UNITED STATES OF AMERICA
NUCLEAR REGULATORY COMMISSION

ADVISORY COMMITTEE ON REACTOR SAFEGUARDS

SUBCOMMITTEE ON EMERGENCY CORE COOLING
SYSTEMS

Date: Tuesday, July 19, 1983

MIST REACTOR VESSEL VENT VALVE SIMULATION

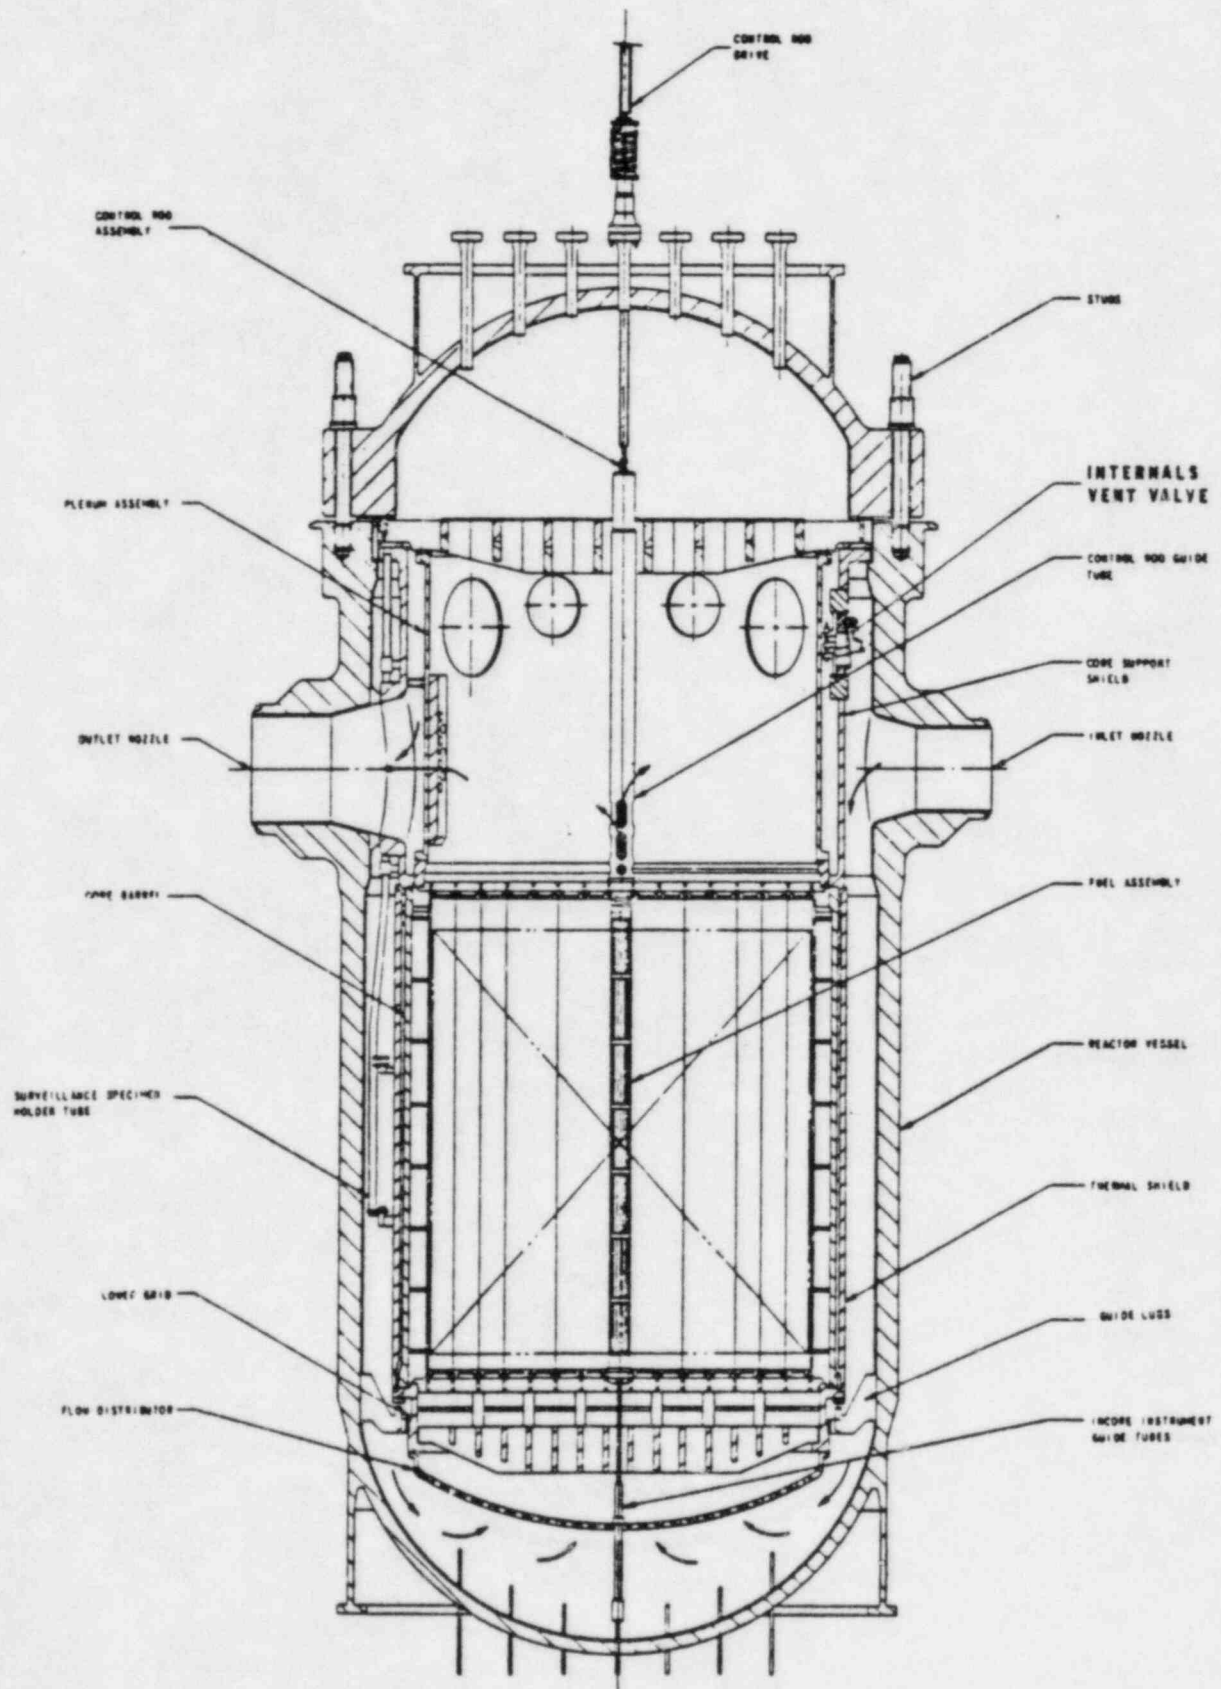
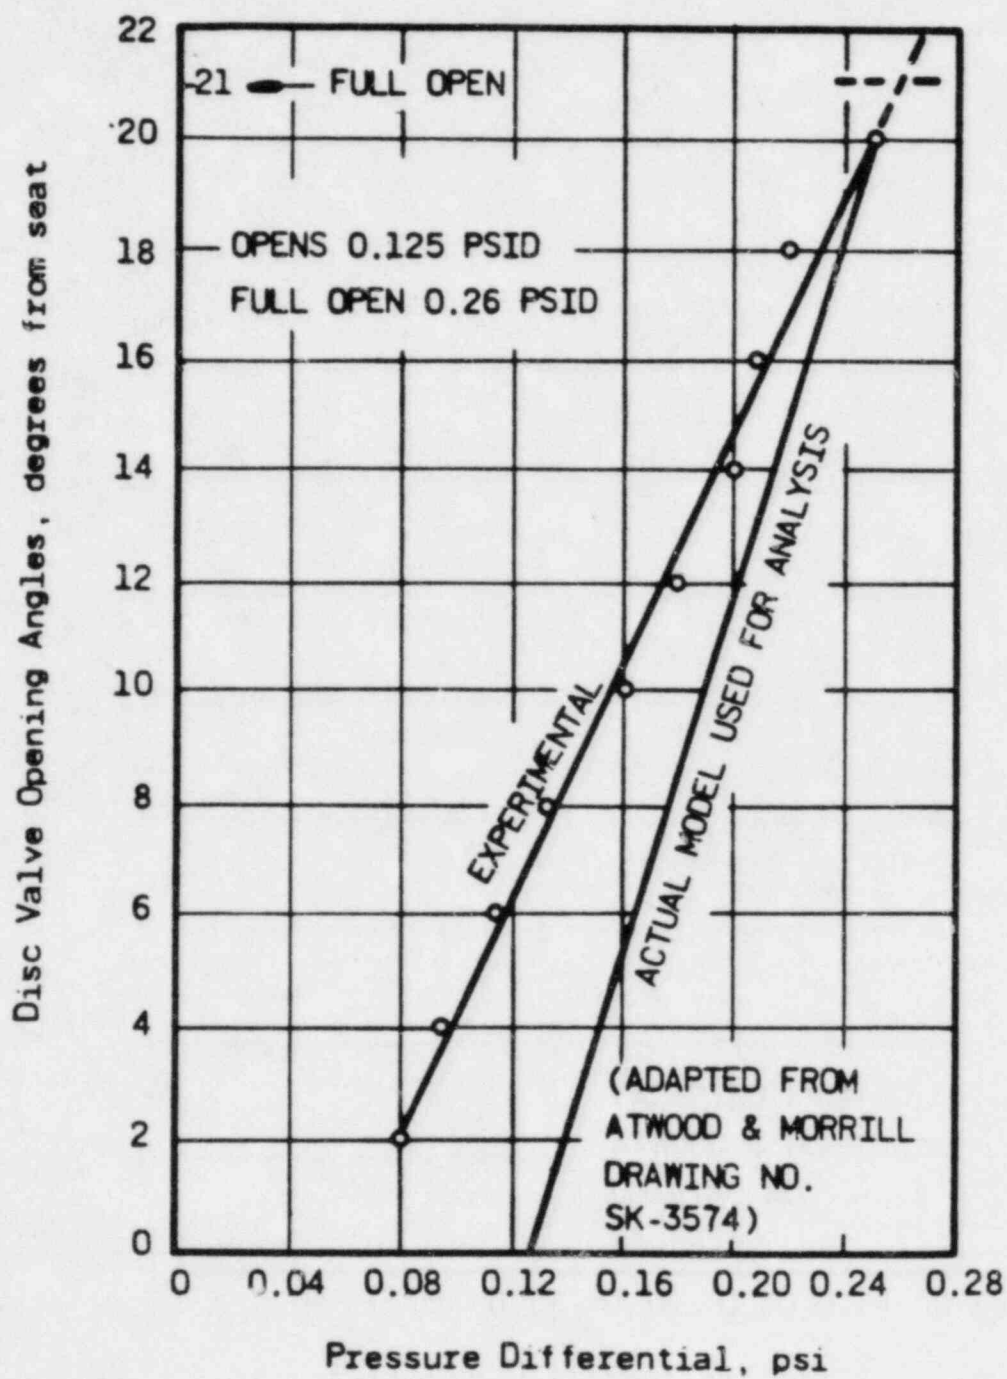
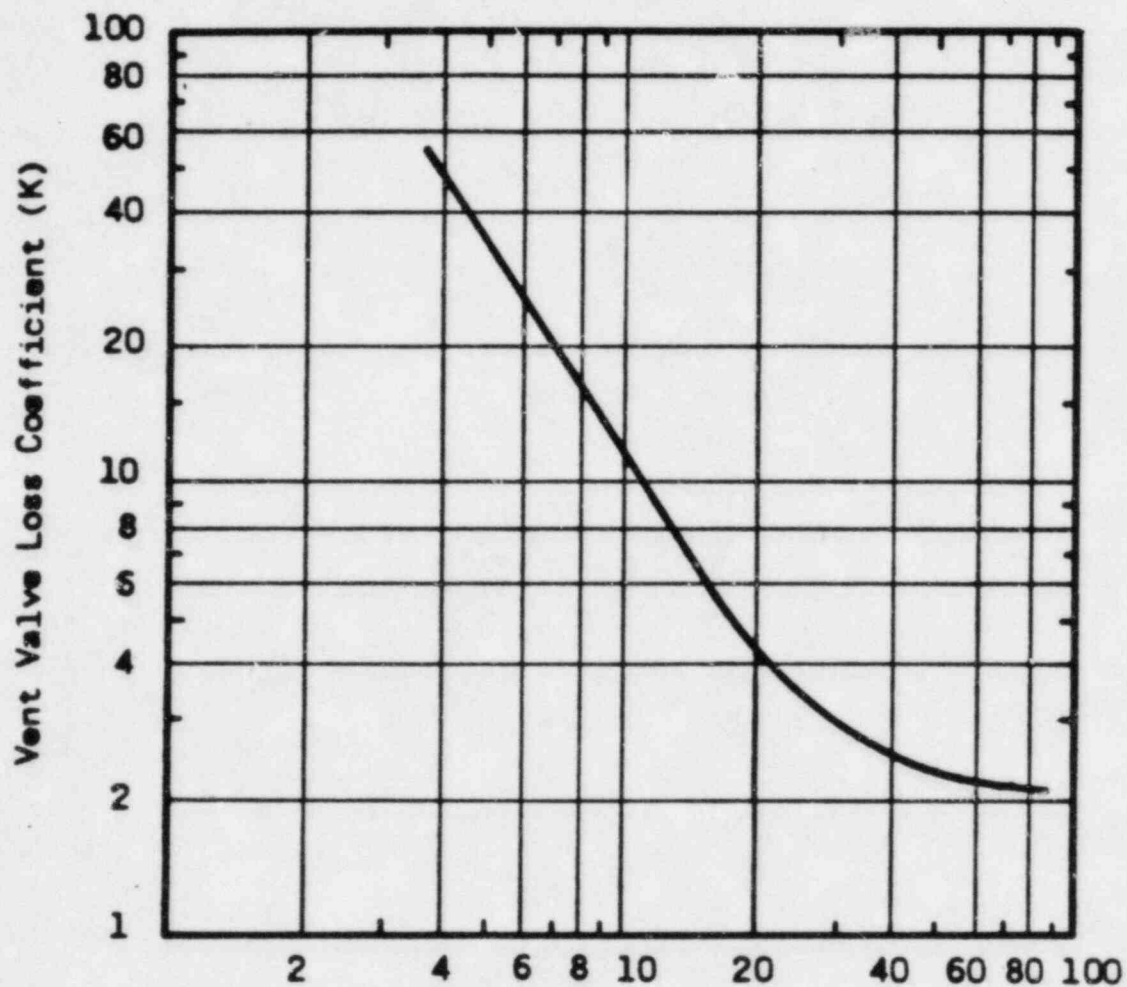
22 MR. MICHELSON: Let me comment on the vent
23 valve problem. It appears that the vent valve is going to
24 be controlled in the facility by a differential pressure
25 indication. In the real world it is also controlled by a

1 differential pressure but of a little different hydraulic
2 arrangement. It is not clear to me in the facility that
3 using a signal in either opening or closing that valve is
4 really going to simulate what the vent valves in the real
5 world will do. So maybe later on you will want to comment
6 on why you believe these facilities can simulate reactor
7 vent valve operation.

12 MR. MICHELSON: Would you comment now on why
13 you felt the bypass, the hot leg bypass that occurs
14 between the shroud and the hot leg interface was not
15 considered important and therefore not simulated?

17 MR. MICHELSON: This is the intersection of the
18 hot leg with the shroud of the reactor vessel in the
19 mechanical joint, a very loose one, as a matter of fact,
20 having an eighth inch or so clearance, and therefore it
21 bypasses the fluid from the hot leg back to the downcomer.
22 It is not a large bypass necessarily and the question is
23 is this significant, particularly if there is steam in the
24 hot log and liquid on the cold leg side or the downcomer
25 side.

8 MS. KEANE: Okay. I think I will probably have
9 to defer that to the detailed design of this vent valve.
10 Again, I think this design will show some things and not
11 other things.

1 MS. KEANE: I am not sure why it didn't show up
2 on this list. It didn't occur to us.

5 MR. SHERON: I think again that is an item that
6 has to be studied as part of the design of the test
7 facility. With respect to the layout of the plant with the
8 external downcomer, the vent valve itself is being
9 represented as a valve in just sort of a crossover line,
10 and I would see very little difficulty in putting a
11 parallel type of bypass line around that vent valve.
